APPLICATION NO.	FILING DATE	FIRST NAMED INVENTOR	ATTORNEY DOCKET NO.	CONFIRMATION NO.
10/553,044	10/13/2005	Torayuki Tsukada	10921.361USWO	1677

Office Action Summary

DETAILED ACTION***Claim Rejections - 35 USC § 102***

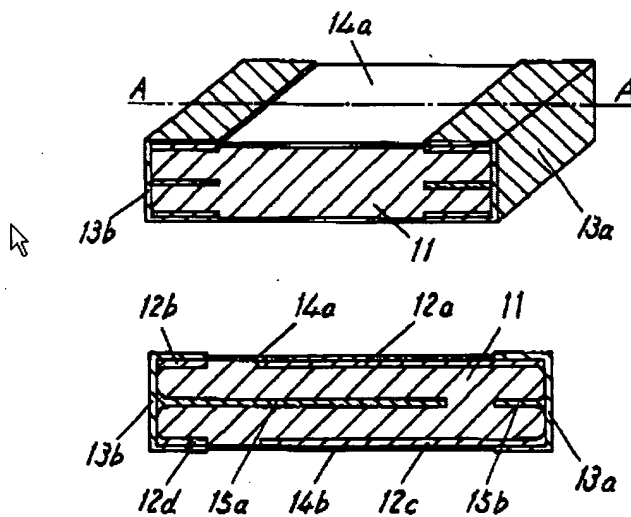
2. Claims 1-13 are rejected under 35 U.S.C. 102(b) as being anticipated by Kojima et al., U.S. Patent 6,348,852 B1.
3. Kojima discloses a chip resistor as claimed. See **FIGS. 1(a)-11(b)**, where Kojima teaches the following limitations.

4. Pertaining to claim 1, Kojima discloses a chip resistor comprising:
a resistor element including a first surface and a second surface opposite to the first surface;

at least two main electrodes **12a**, **12b** spaced from each other and provided on the first surface; and

at least two auxiliary electrodes **12c** and **12d** spaced from each other and provided on the second surface, the auxiliary electrodes facing the main electrodes via the resistor element **11**;

wherein the main electrodes and the auxiliary electrodes are made of the same material (i.e., copper foil, see column 3, lines 43-44).

5. Pertaining to claim 2, Kojima teaches the chip resistor according to claim 1, wherein a spacing distance between the auxiliary electrodes is no smaller than a spacing distance between the main electrodes (please note that the gap between electrodes **12a** and **12b** is the same distance between electrodes **12d** and **12c**).

6. Pertaining to claim 3, Kojima teaches the chip resistor according to claim 1, further comprising a first insulating layer **14a** and a second insulating layer **14b** formed on the resistor element, wherein the first insulating layer covers an area between the main electrodes on the first surface of the resistor element, and the second insulating layer covers an area between the auxiliary electrodes on the second surface of the resistor element.

8. Pertaining to claim 5, Kojima teaches the chip resistor according to claim 1, further comprising at least two solder layers **13a**, **13b** formed on the resistor element, wherein the resistor element includes a pair of end surfaces spaced from each other, each of the end surfaces being covered by a corresponding one of the two solder layers.

The image above is attributed to Ko, where surfaces 12a, 12b and 12c are insulating layers.

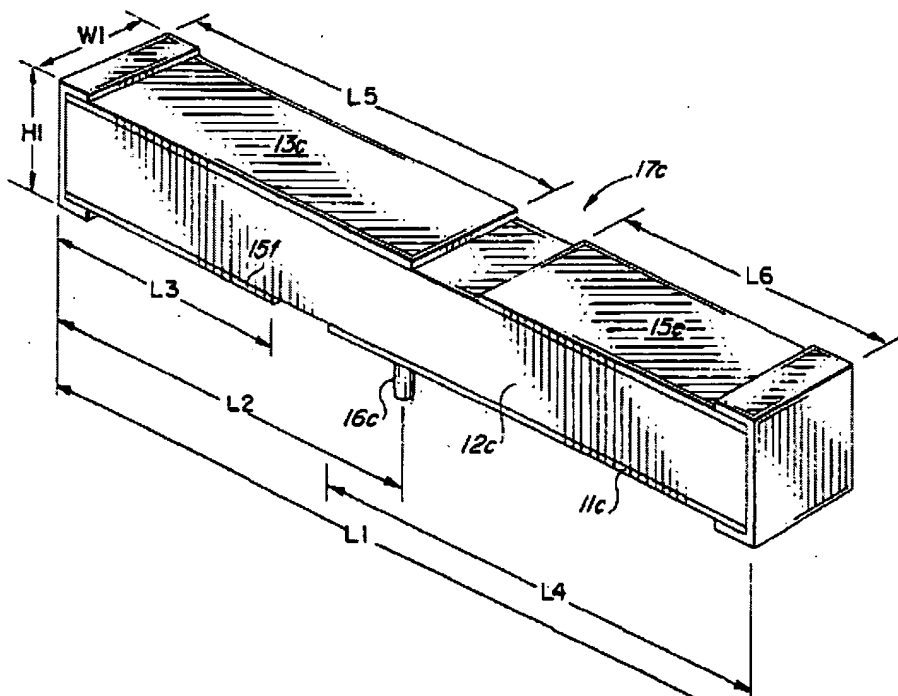
Kojima discloses a semiconductor device and process substantially as claimed. However, Kojima fails for form a third insulating layer wherein the side surface is covered by a third insulating layer.

In view of Ko, it would have been obvious to one of ordinary skill in the art to incorporate the chip resistor fabrication methods of Ko into the Kojima semiconductor process because the stacked dielectric located on the ground plate will prevent leaking current (see column 11, lines 1-7).
